# PERMIT

## SEWAGE DISPOSAL SYSTEM

SUBDIVISION Greenwood Farms LOT 42 ROAD 7542 Greenwood Drive

REPAIR TO ESTABLISH ADDITIONAL SEPTIC CAPACITY IN SUPPORT OF BP# 35269. CALL FOR INSPECTION WHEN GROUND IS OPENED SO SANITARIAN CAN RECOMMEND REPAIR.

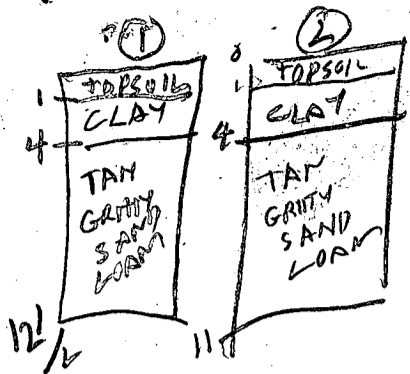
REMARKS: 11/14/90 BACK HOLE BROKE HOLE ① NOT DEEP ENOUGH (SHOULD BE 12 FT.) HOLE 2 NOT DUG RECOMMEND 2 HOLES EACH 12 FT DEEP)

BACK HOLE OPERATOR WILL CALL FOR ANOTHER APPOINTMENT ALL

12/14/90 P. M. ① Holes - down to 5' info. no machine on site; CBS; no change 1:30. No hole dug. Waited. Dick Oster at site - no machine.

12/17/90 VISUAL HOLES OK FOR PERMIT FOR ADDITION

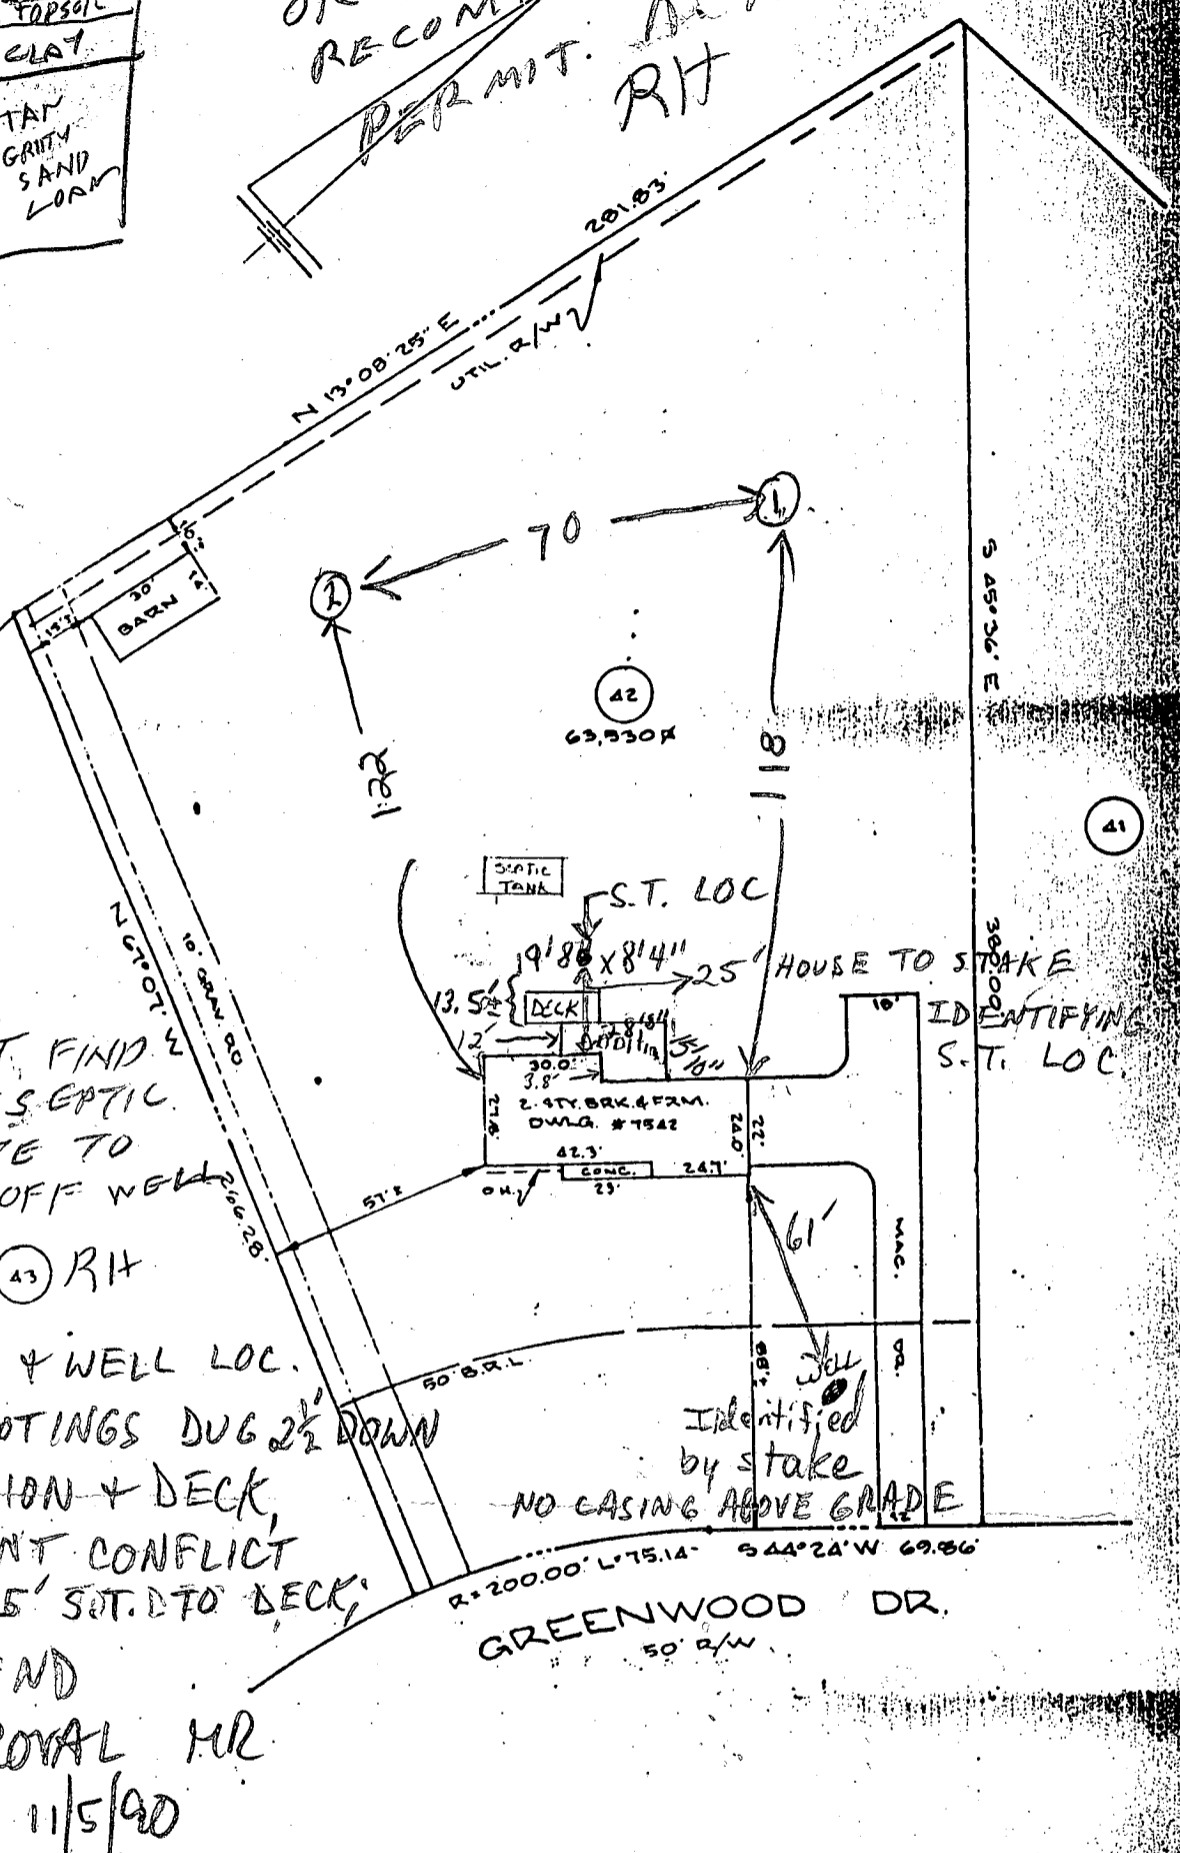
SEPTIC TANK NOT TOO CLOSE TO DECK PER MEASUREMENTS  
ON INSPECTION SHEETS ALTHOUGH CLEANOUT NOT FOUND RH

12/18/90  
 VISUAL HOLES  
 OK FOR FUTURE  
 RECOMBENT  
 PERMIT. RIT  
 REPAIR BUILDING  
 APPROVA

11/11/90  
 COULD NOT FIND  
 WELL OR SEPTIC.  
 LEFT NOTE TO  
 STAKE OFF WELL  
 & SEPTIC (43) RIT

11/5/90 S.T. & WELL LOC.  
 STAKED; FOOTINGS DUG 2 1/2' DOWN  
 FOR ADDITION & DECK,  
 NO APPARENT CONFLICT  
 W/ PIPE; ~5' SOT. D TO DECK;  
 RECOMMEND  
 BP APPROVAL MR  
 11/5/90
